## SPUR 40 AREA SANITARY SEWER IMPROVEMENTS

CITY OF ST. MARYS, GA

T&H PROJECT No.  
J-20953

**ADDENDUM NO. 1**

**BITUMINOUS PAVEMENT  
 DETAIL**

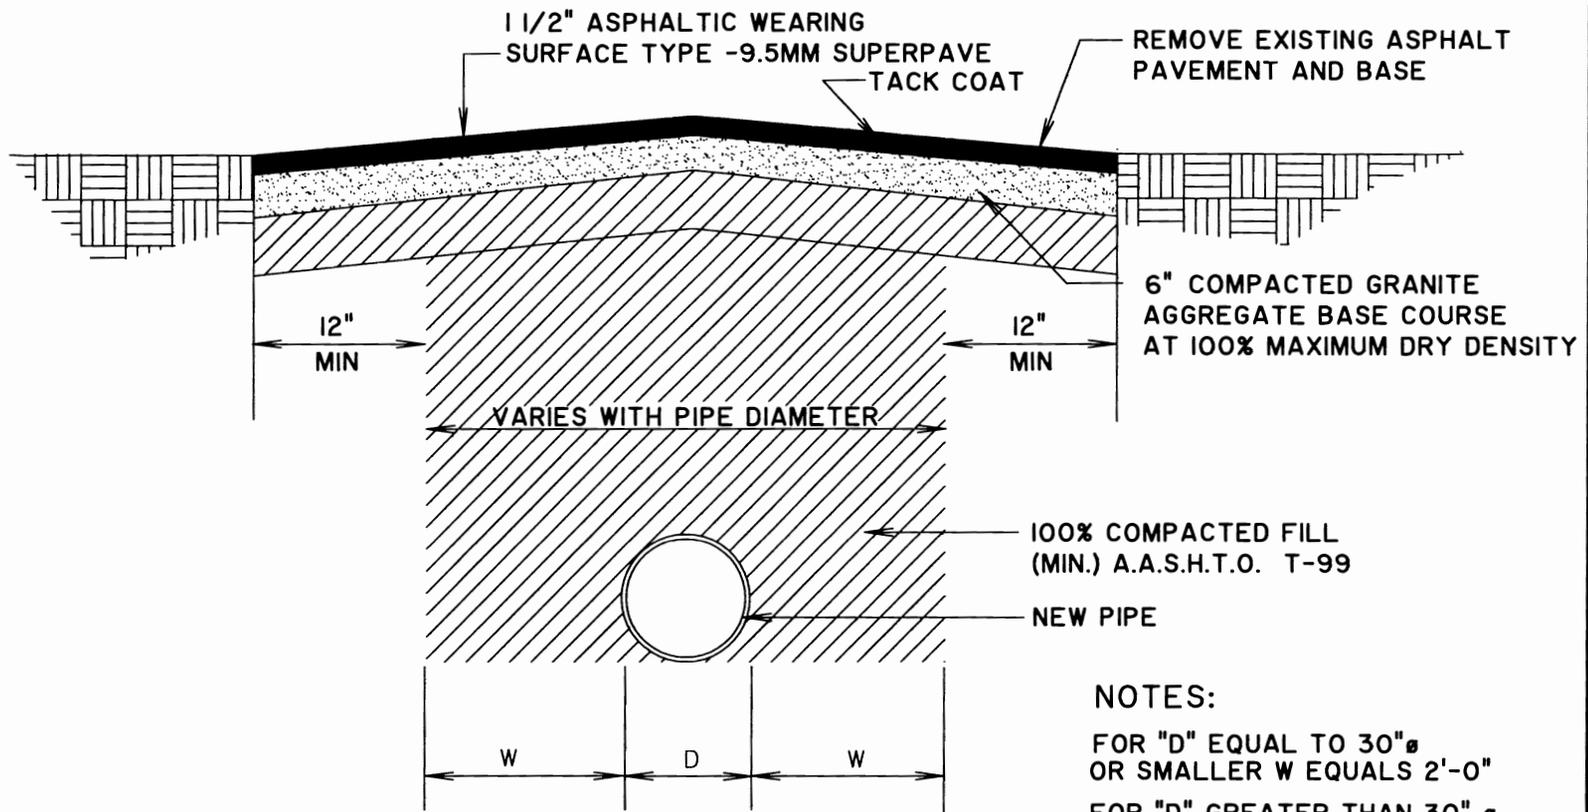
Sheet C43 – Remove and Replacement of Pavement Detail: The attached detail shall replace Detail P96 in the plans. Contractor shall be responsible for removing all existing pavement and base material along roads impacted by the proposed sewer as shown on the plans and replacing with compacted sub-base, 6" GABC and 1-1/2 inch Asphaltic Wearing Course as shown on the attached detail, installed to existing grade.

1. ALL GRADED AGGREGATE MUST COMPLY WITH THE CONTRACT PAVEMENT SPECIFICATIONS.
2. THE GRADED AGGREGATE IS TO BE PLACED IN NO MORE THAN 6 INCH LIFTS AND COMPACTED TO 100% STANDARD PROCTOR (ASTM D 698-00). THE IN-PLACE DENSITY IS TO BE TESTED BY METHOD ASTM D 2922-96e1 OR ASTM D 1556-00.
3. LONGITUDINAL CUTS EXCEEDING 150 FT. IN LENGTH, THE GRADED AGGREGATED IN TRENCH WILL BE BROUGHT FLUSH WITH THE EXISTING PAVEMENT AND THE ENTIRE WIDTH OF ROADWAY RESURFACED WITH A MINIMUM OF 1" OF TYPE "E" ASPHALT TOPPING OR SURFACE COURSE.
